To: All Prospective Bidders
Re: Plyler Park Renovation
Date: January 2018

We would like to take this opportunity to inform you that the Plyler Park Renovation Invitation for Bid (IFB #18-B0073) has been cancelled in its entirety. We would also like to inform you that a new Invitation for Bid (IFB #18-B0094) for the Plyler Park Renovation project has been created. The Plyler Park Renovation Drawings, Addenda 1 thru 8 and revised Specifications associated with IFB #18-B0073, as well as this Cover Sheet outlining applicable information, shall hereby be incorporated and be made part of this current Invitation for Bid (IFB #18-B0094).

Plyler Park Renovation

Questions and Answers
Pre-Bid Conference for Plyer Park Renovation
December 8, 2017

NOTES:

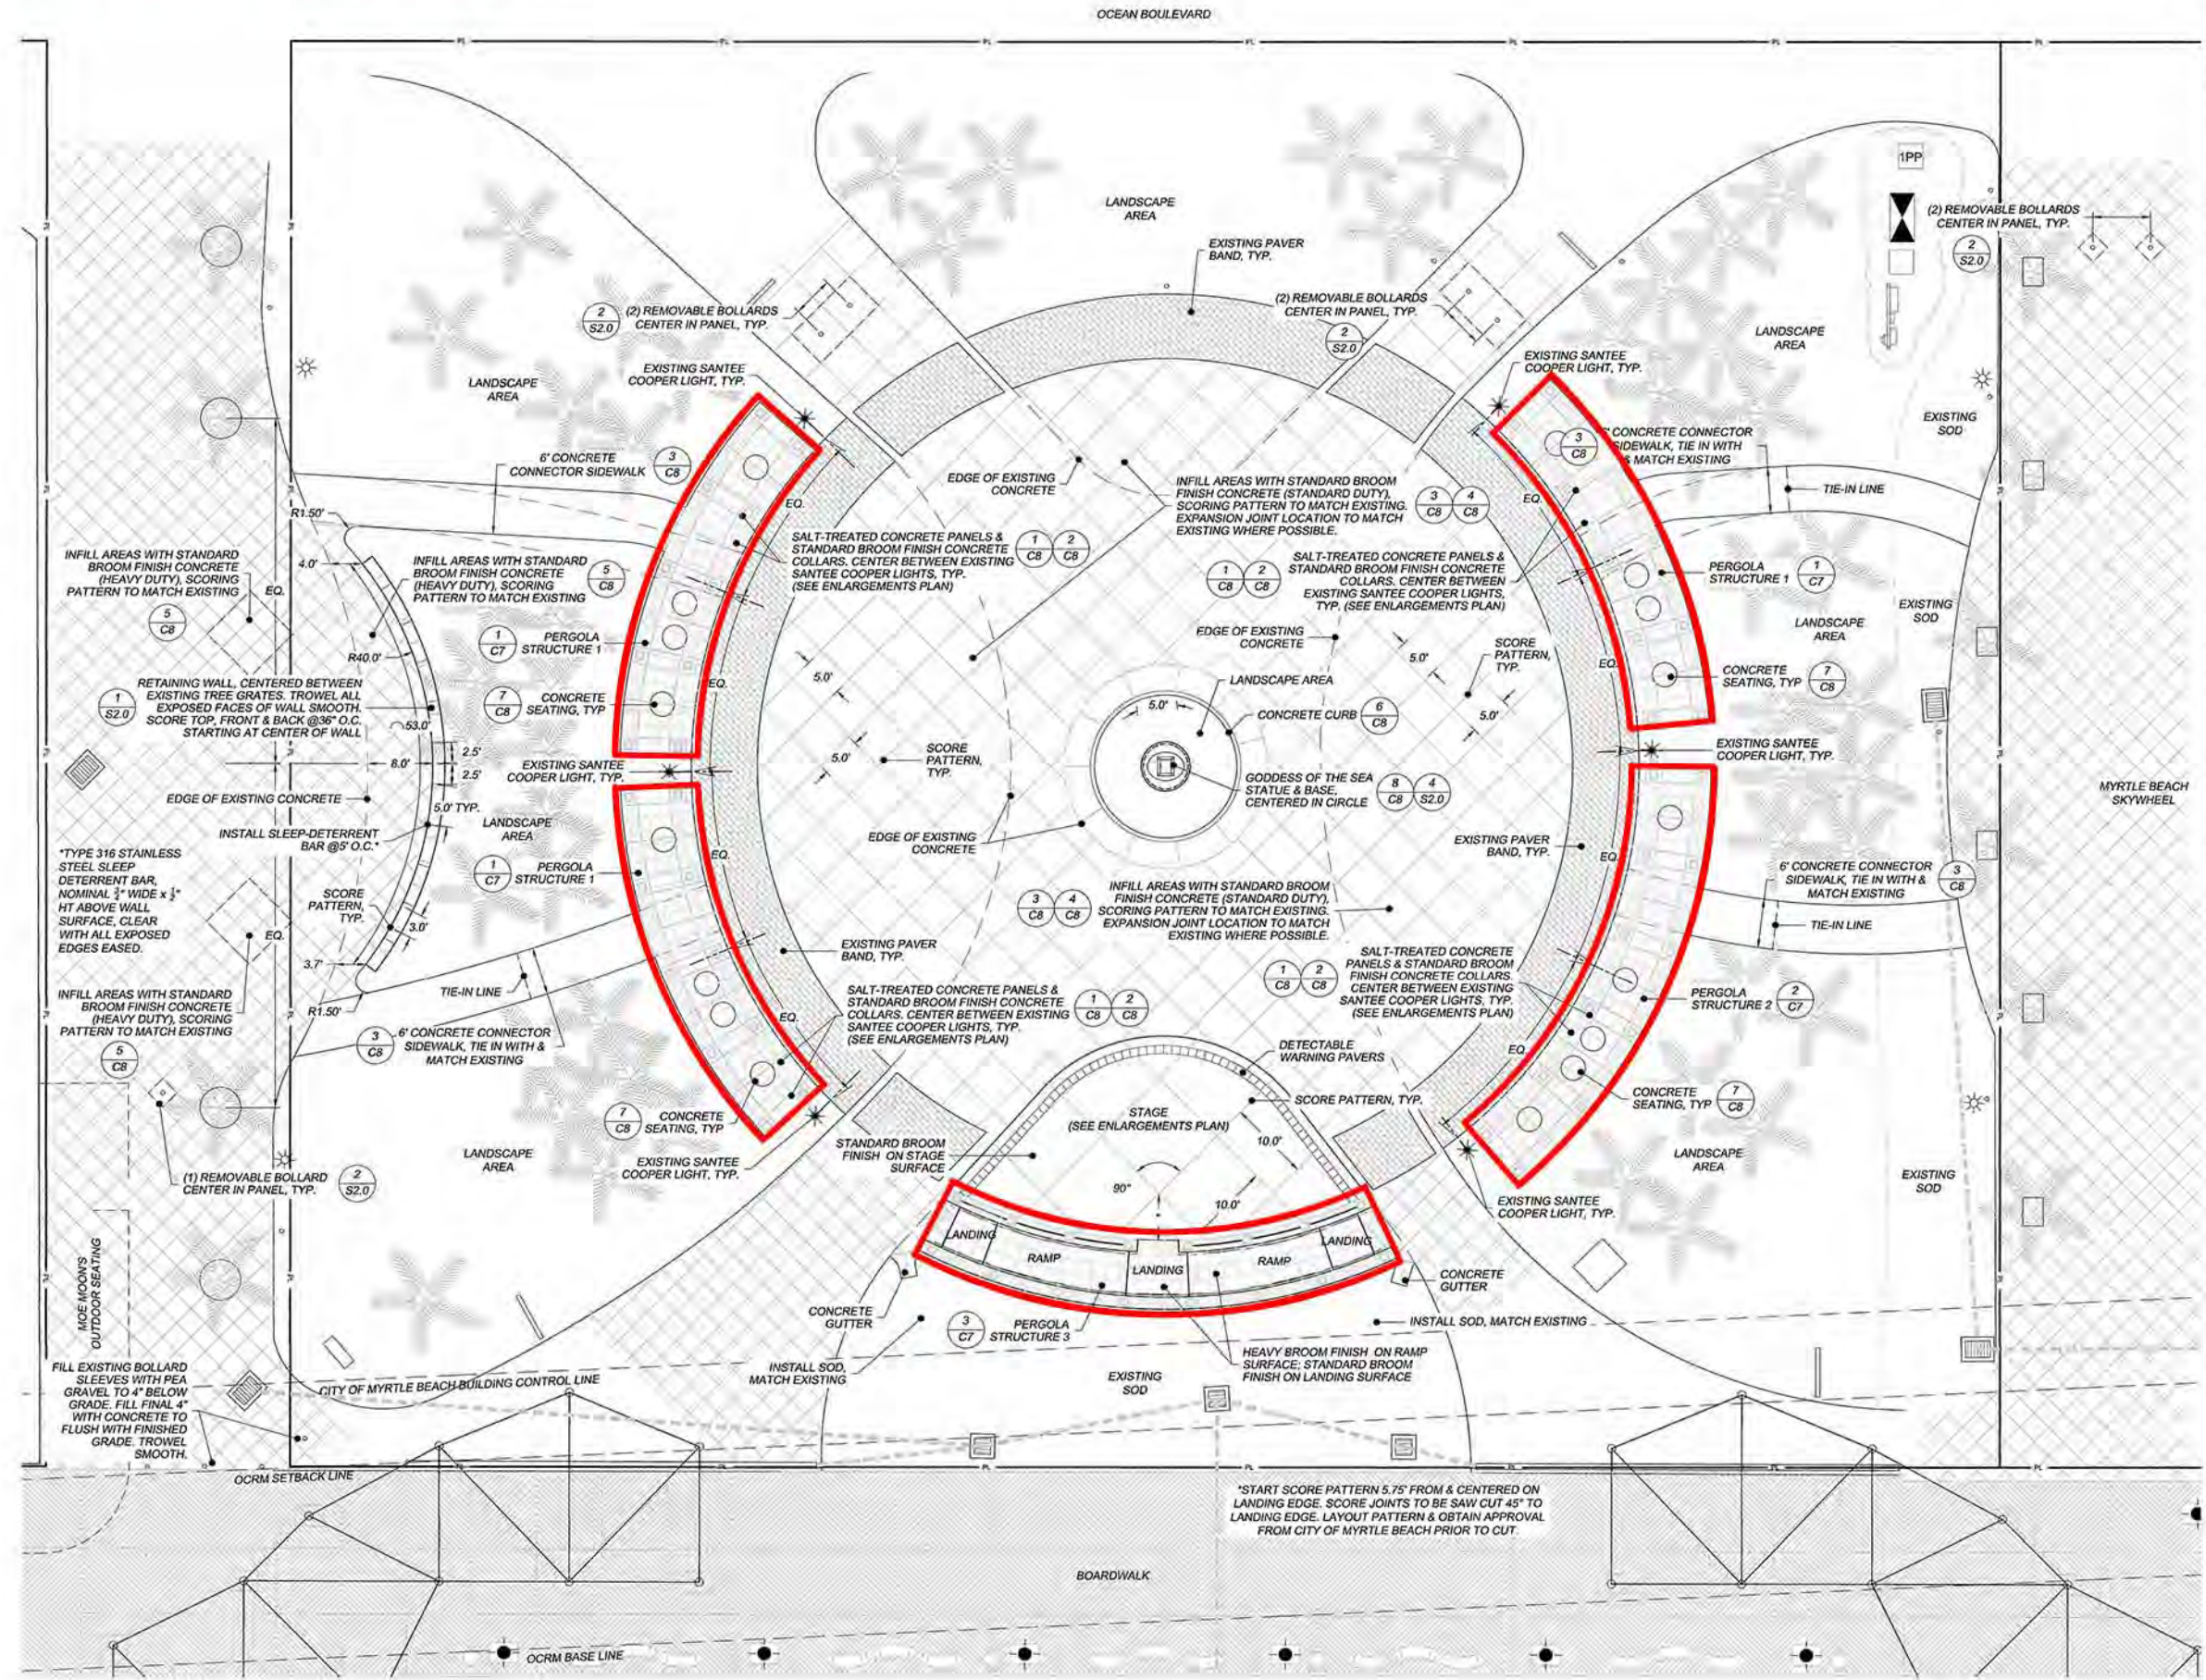
5. Q: Landscaping - No plans to tell us what to plant.

Please see attached for L1, L2 and the revised irrigation sheets. Also, see revised plan and notes on E1.0 and attachment for fixture specification. Fixture shall be 18W 4000K color temperature with black finish. Contractor shall replace existing Drawing and Addendum #3 clarification item with the revised Drawing.

A: No plant material, with the exception of a small amount of sod behind the stage, is included in this contract. Please refer to C4 for direction in the landscape areas.

ADDENDUM 7 - DRAWING 1

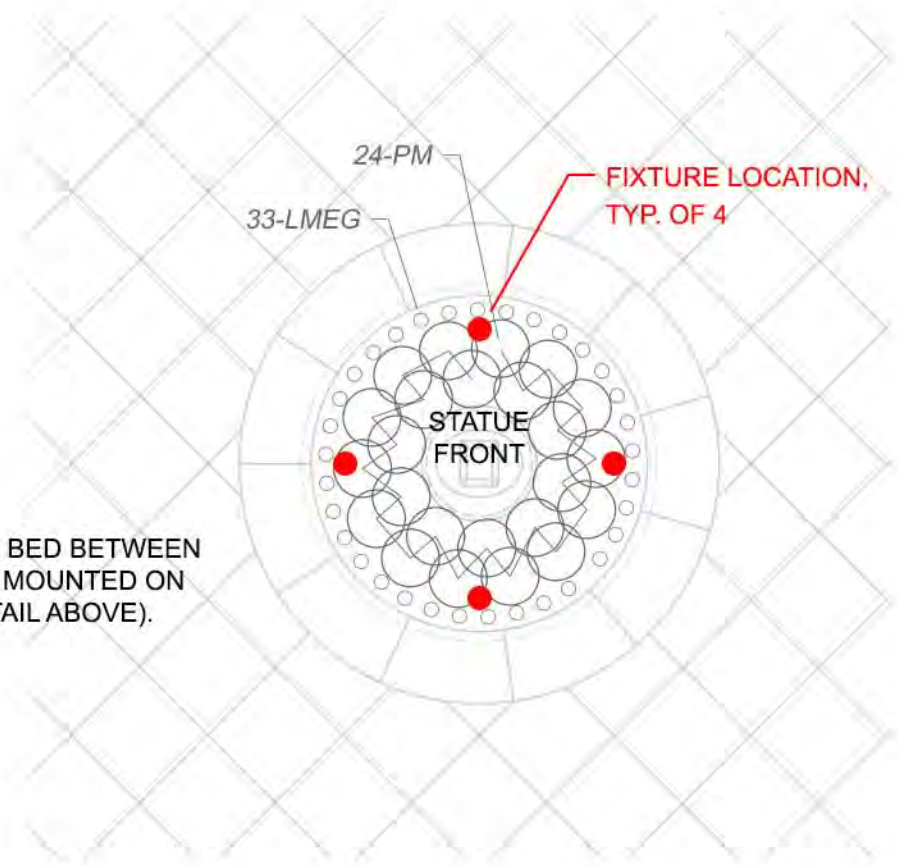
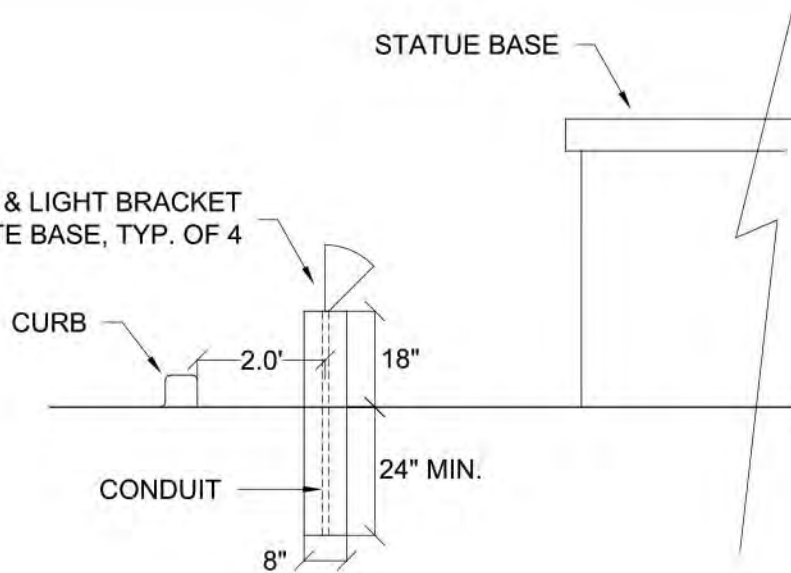
- Item #2: Please see Addendum 7 Drawing 1 for clarification/detail of the statue lighting installation.
- Item #3: Contractors are to be made aware that the Scope of Work has been reduced to the Base Bid (Goddess of the Sea) and Alternate 1 (Stage). Please see revised Specification Sections 0200, 0300 and 0650.

LIGHTING FIXTURE & LIGHT BRACKET ON 8" DIA CONCRETE BASE, TYP. OF 4

INSTALL FIXTURES IN LANDSCAPE BED BETWEEN PM & LMEG, 24" INSIDE CURB AND MOUNTED ON AN 18" CONCRETE BASE (PER DETAIL ABOVE).
